**MOORE PUBLIC SCHOOLS -  
HIGHLAND EAST JUNIOR HIGH SCHOOL  
STEM ADDITION**

-----  
**ADDENDUM NO. 1**

January 26, 2022  
-----

**ADDENDUM No. 1**

WDB ENGINEERING P.L.L.C. SHEET NUMBER DD1

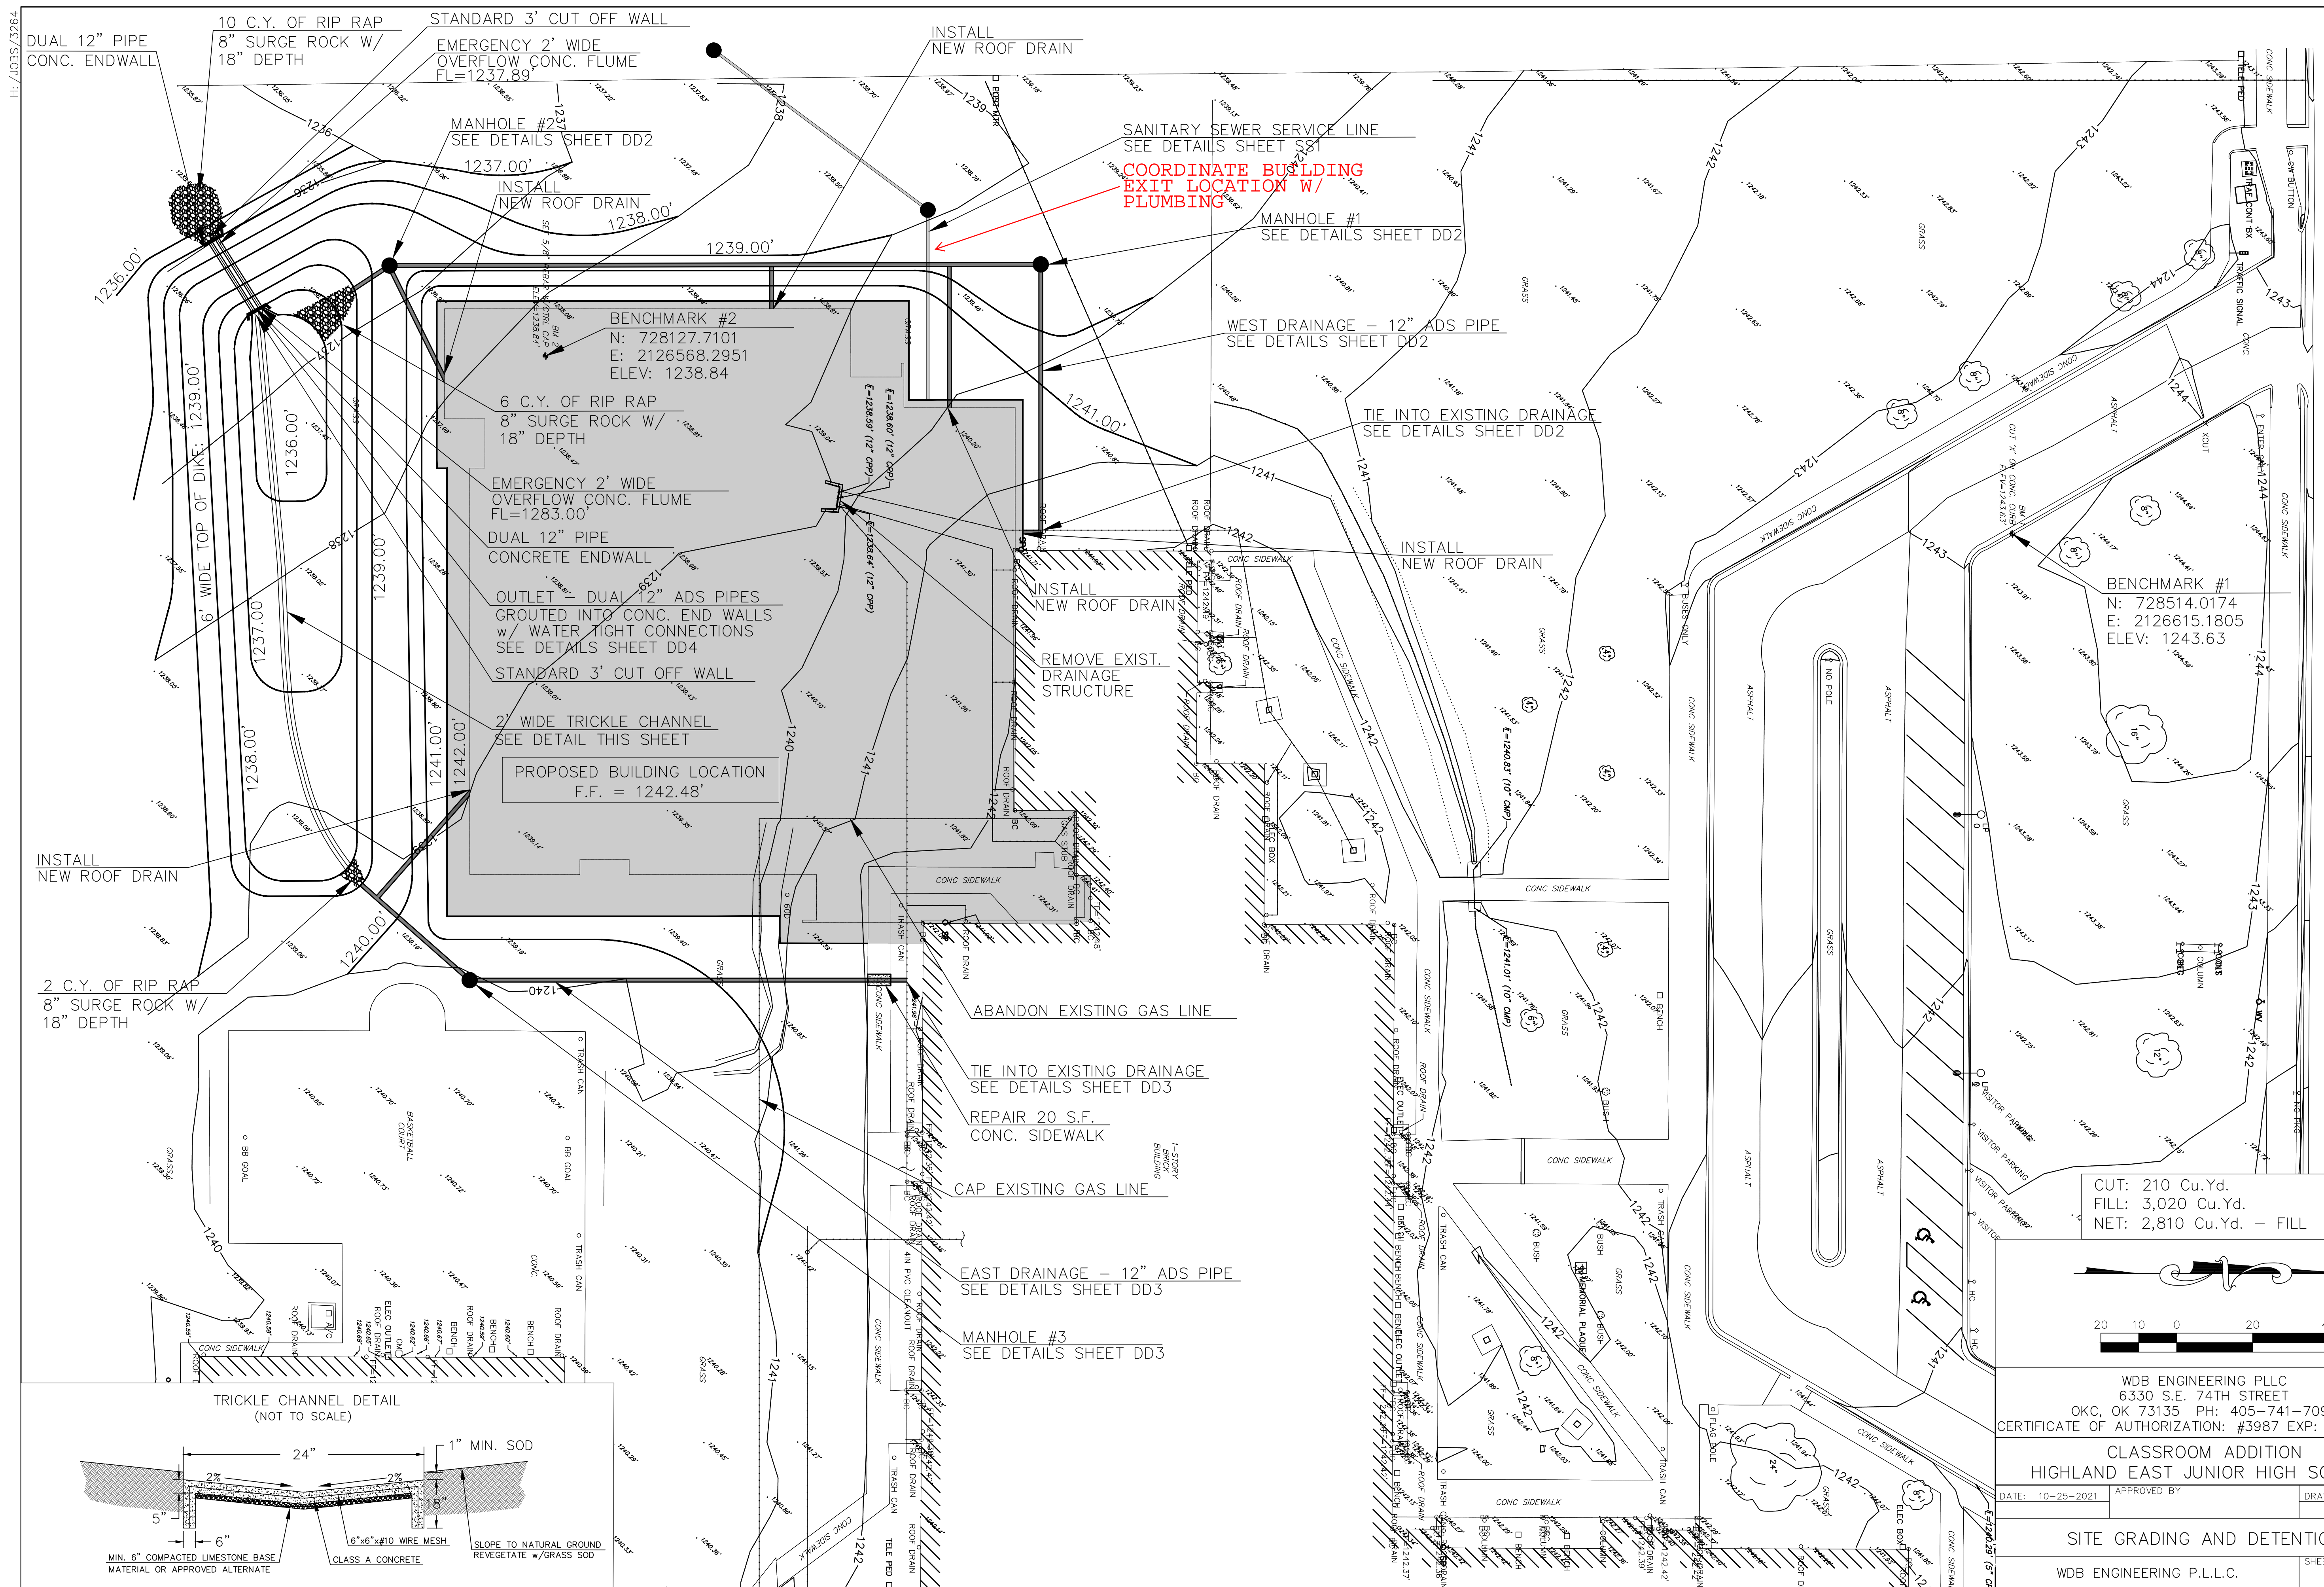
1. Sheet DD1, Site Grading and Detention: added plumbing coordination note at the northwest corner of the building. Refer to attachment.
2. Sheet SS1, Sanitary Sewer Service Line Profile: added plumbing coordination note at the northwest corner of the building. Refer to attachment.
3. Sheet C300, Detail #1, Paving Site Plan: revise sidewalk / mow strip locations as per attached revised drawing.
4. Sheet C600, Detail #1, Erosion Control Site Plan: locate construction lay-down area as per attached revised drawing.
5. Sheet C601, Detail #1, Laydown / Gravel Site Plan: locate and detail construction lay-down area as per attached revised drawing.

COORDINATE BUILDING EXIT LOCATION W/ PLUMBING

Sheet No:  
**C601**

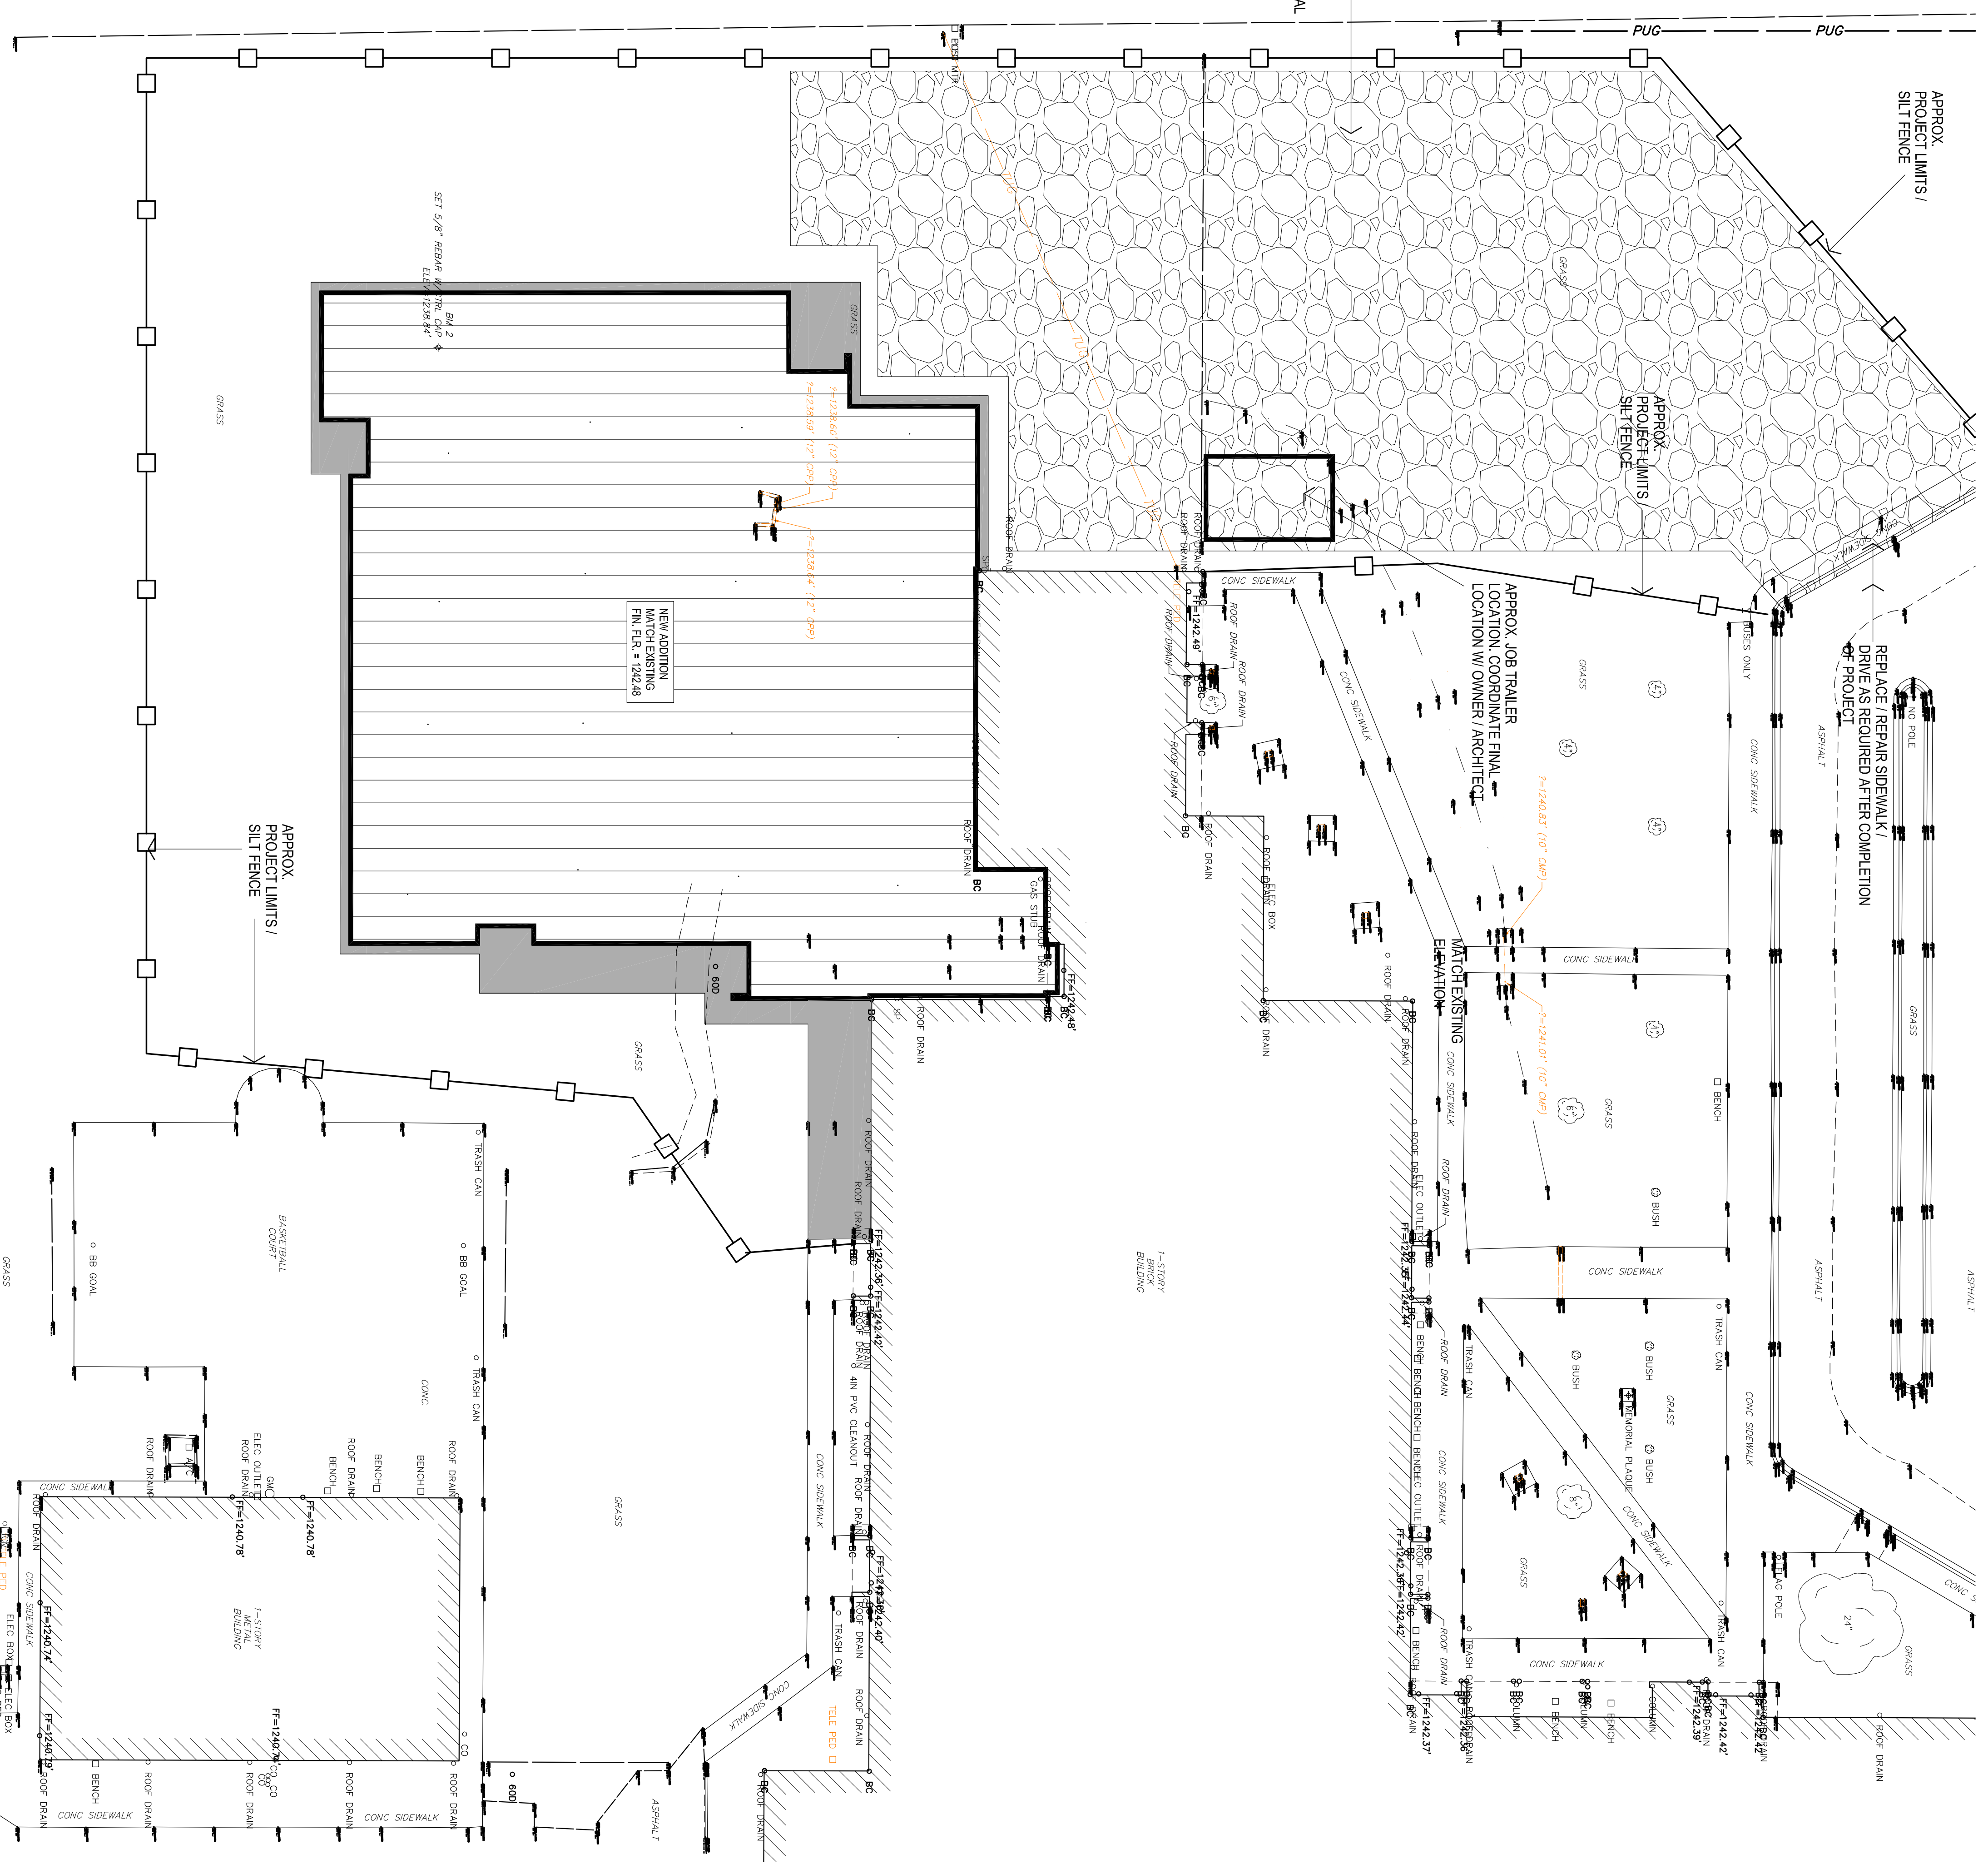
SITE LAYDOWN / ENTRY  
GRAVEL AREA APPROX.  
25,000 SQ. FT. PROVIDE  
GRAVEL, MATS & TEMPORARY  
PIPING TO PROVIDE  
PROPER DRAINAGE DURING  
CONSTRUCTION. COORDINATE FINAL  
LOCATION W/ OWNER / ARCHITECT

# A103

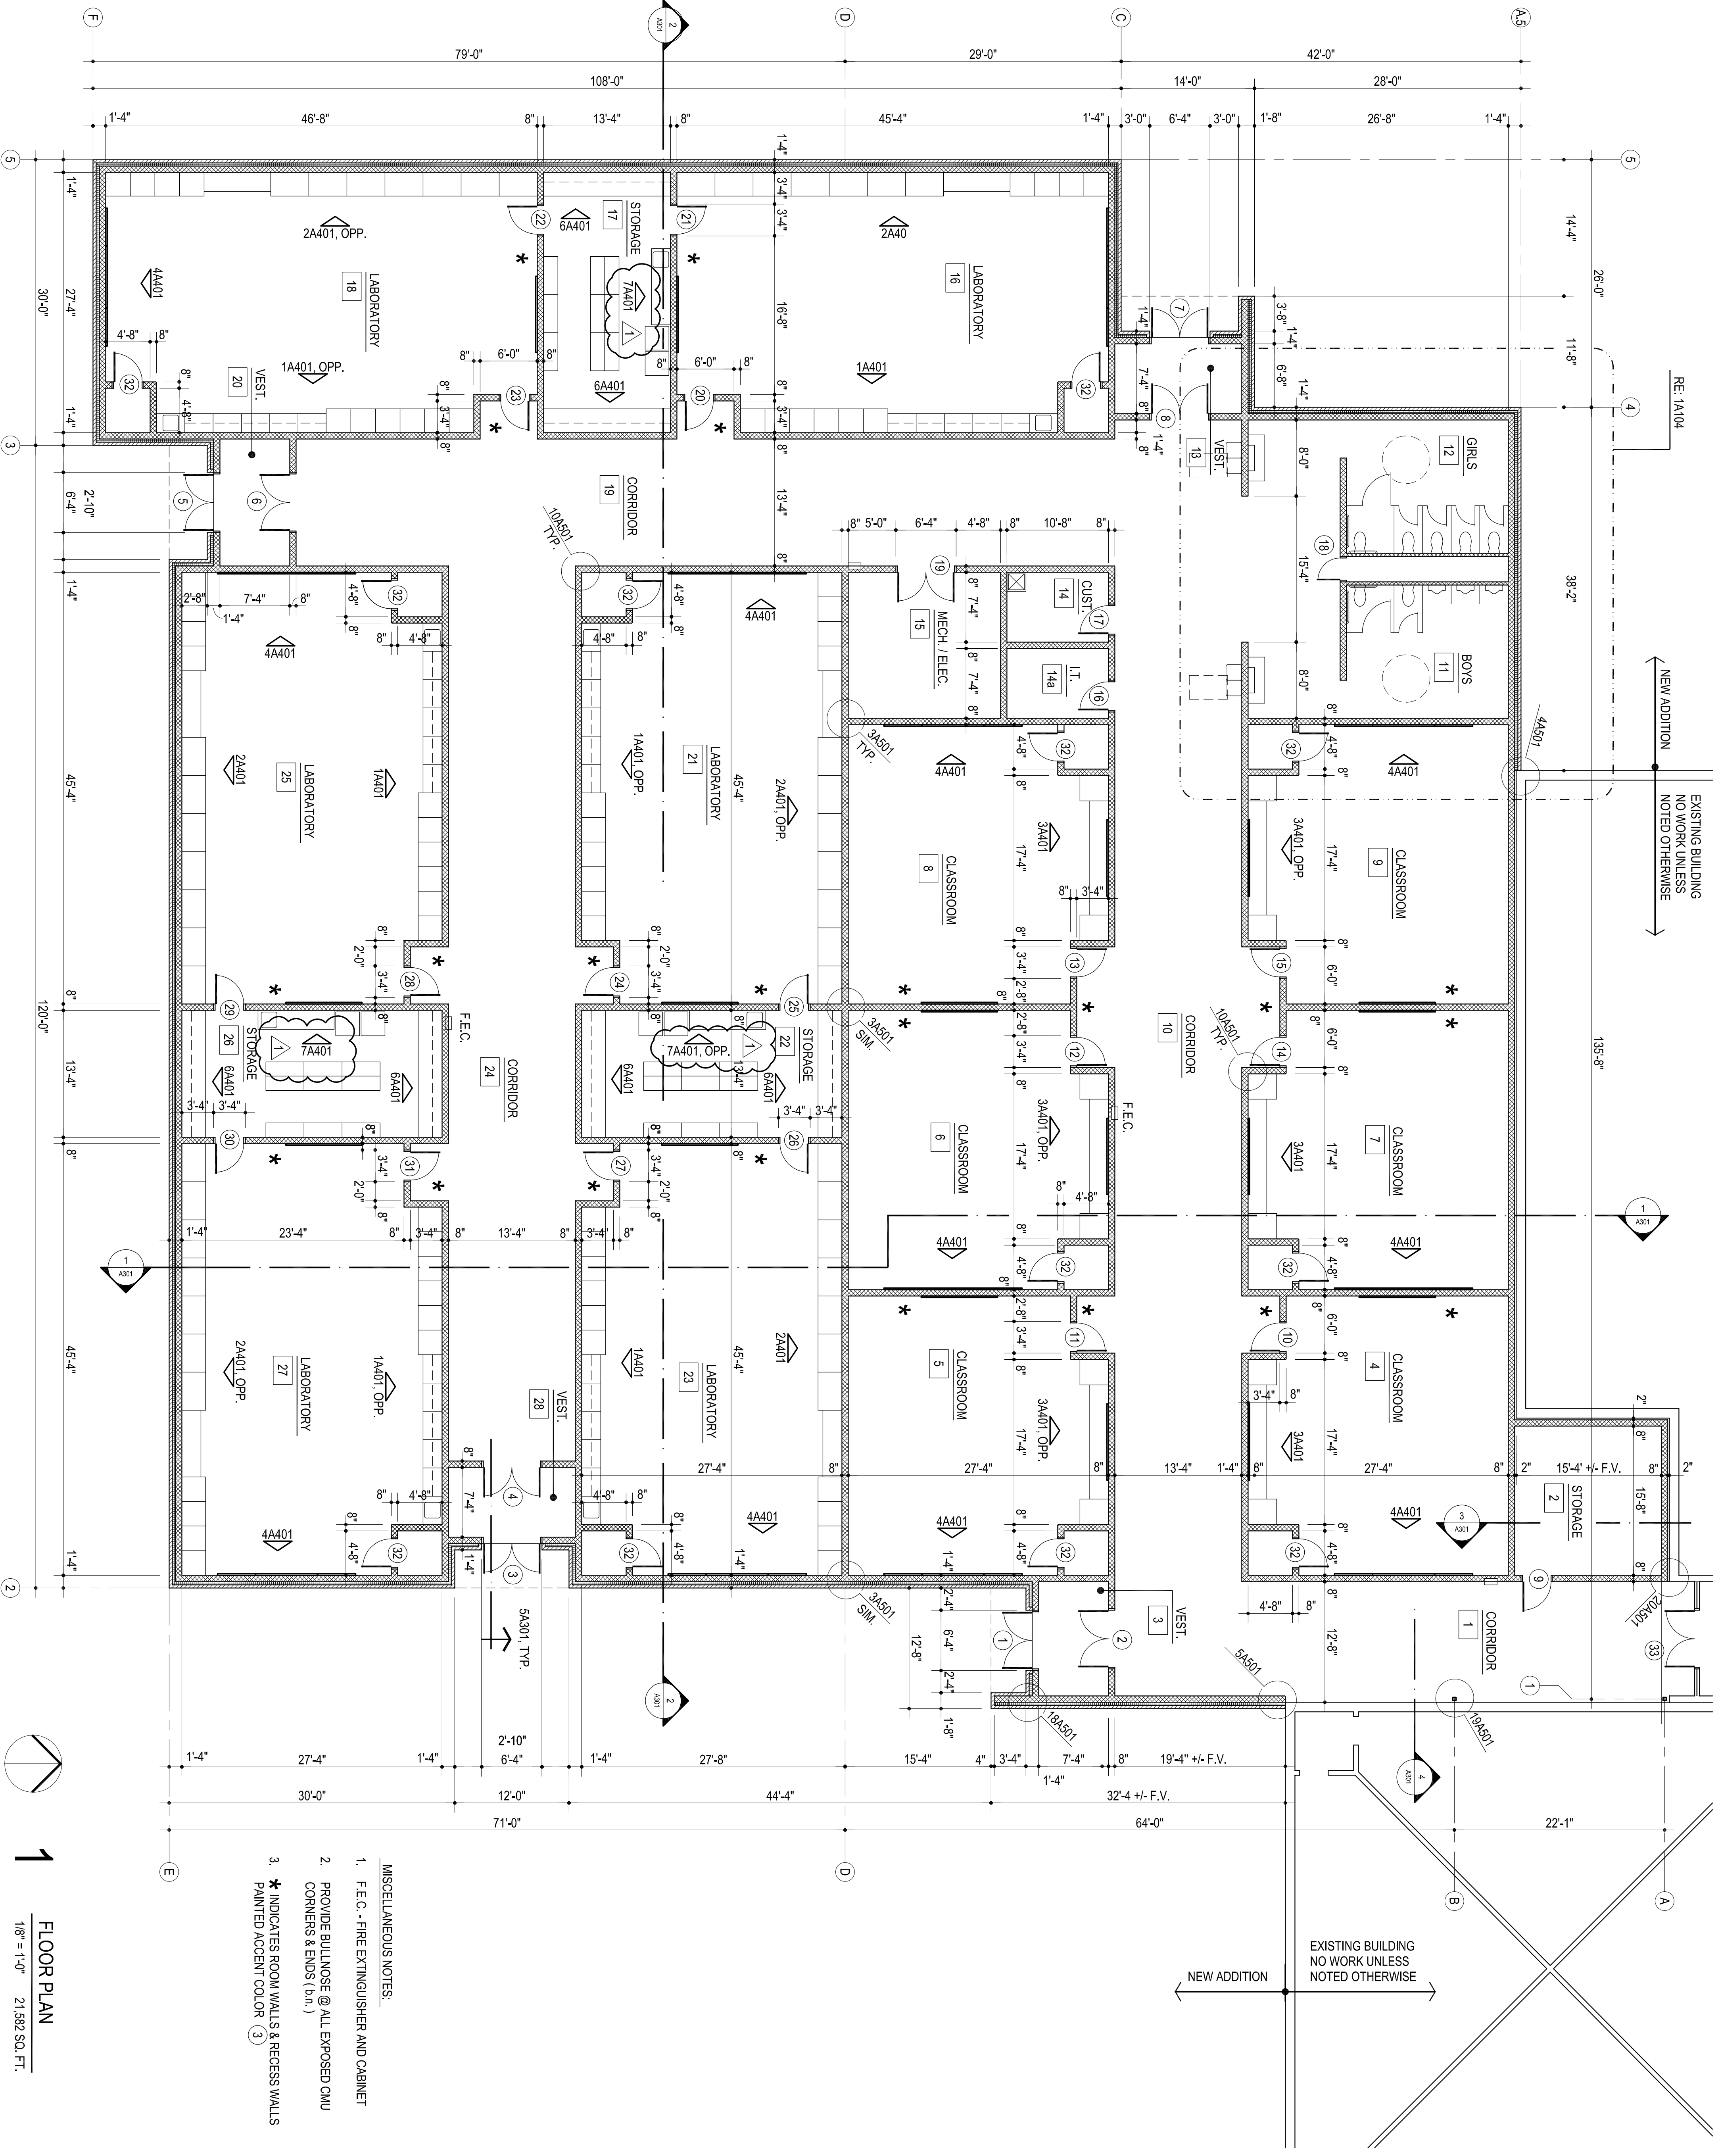
1. Sheet A103, Detail #1, Floor Plan: revise interior elevation referencing in Rooms #17, 22, and 26 as per attached revised drawing.
2. Sheet A401, Detail #2, Elevation at Typical Lab: revised number of equal spaces for shelving to "7 spaces" in lieu of six as indicated. Refer to attachment.
3. Sheet A501, Detail #20, Plan Detail and Sheet 601, Detail #2, Color Schedule: refer to attached Request for Information #2 for clarifications.
